UNITED STATES PATENT AND TRADEMARK OFFICE

Office Action Summary	Application No. 10/542,975	Applicant(s) MARTIN, ALASTAIR J.	
	Examiner THOMAS MCEVOY	Art Unit 3731

DETAILED ACTION

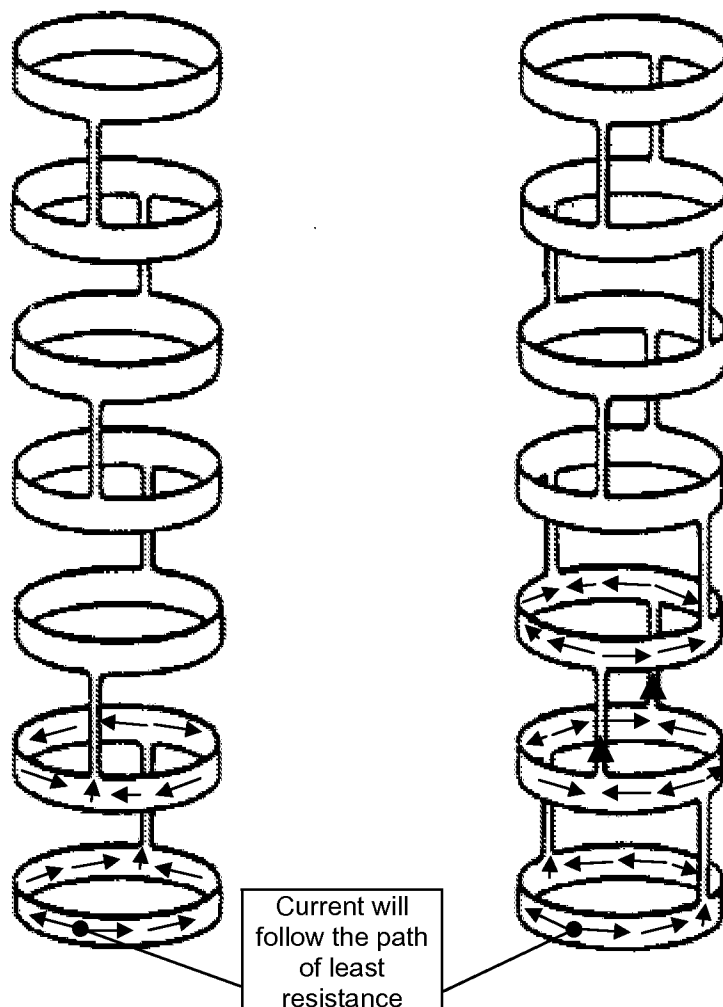
Regarding claim 12, Lau et al. disclose a stent for use in intravascular therapy, the stent comprising: a plurality of electrically conductive elements arranged in a generally tubular structure, the conductive elements comprising generally diagonally arranged struts with respect to a central axis of the stent (Figures 1-3), the conductive elements comprising: a plurality of loops 12 disposed about a central axis of the stent; and a plurality of linking members 13 for joining the loops such that the loops and linking members form a generally tubular structure around the central axis of the stent. Lau et al. fail to disclose a plurality of non-conductive connector nodes as claimed. Pacetti discloses non-conductive connector nodes which minimize current loops (paragraph 0038; improvements in MRI imaging have been made at and shortly after the time of Pacetti's invention - see attached Notice of References Cited) flowing within a stent in order to enable better MRI imaging (Abstract, paragraphs 0033, 0035 and 0038). One of ordinary skill in the art would have recognized the benefit of this modification to the Lau et al. stent because it is well-known in the art to use MRI imaging when deploying stents of similar function and structure to those of Lau et al. Therefore, it would have been obvious to one of ordinary skill in the art to have placed the nodes of Pacetti anywhere throughout the stents of Lau et al. in order to minimize current loops flowing

within the stent so that MRI imaging is enhanced. With this modification, the nodes would be disposed among the conductive elements and would direct (the nodes at least participate in directing the current along its normal path and would prevent shorts in their immediate vicinity) a current induced by RF signals in an examination region of a magnetic resonance apparatus to flow in the conductive elements such that adjacent segment currents cancel each other and a net current flowing in the stent is substantially minimized (see current flows [→] below; the currents within each loop would substantially cancel or minimize the currents in adjacent loops as evidenced by Applicant's disclosure):

The above combination would also result in the loops and linking members being connected (intra-connected or indirectly inter-connected) within the non-conductive connector nodes such that the current flowing through adjacent loops substantially cancel each other (as shown above). Regarding claim 16, when the undulations of the Lau et al. stent are offset as in Figure 11, they would form an overall diamond-shaped mesh pattern on the stent (when the stent is expanded) and each loop would have a zig-zag pattern. Regarding claim 19, in the Figure 8 embodiment of the Lau et al. stent each zig-zag loop is connected to each neighboring zig-zag loop only once. Regarding claim 9, Lau et al. disclose that the connectors 13 connect neighboring loops at approximately 90 degree intervals (four connectors, col. 5, line 60) and disclose that in other embodiments the connectors are evenly spaced (Figures 8-10). Therefore, it would have been obvious to one of ordinary skill in the art to have distributed the four connectors evenly which would result in 90 degree intervals as claimed. Furthermore regarding claims 19 and 20, as can be seen in the drawings above, the current would flow in opposite directions in adjacent loops no matter how many connectors are used so long as the connectors are radially offset between adjacent loops as disclosed by Lau et al. (col. 5, lines 42-48).
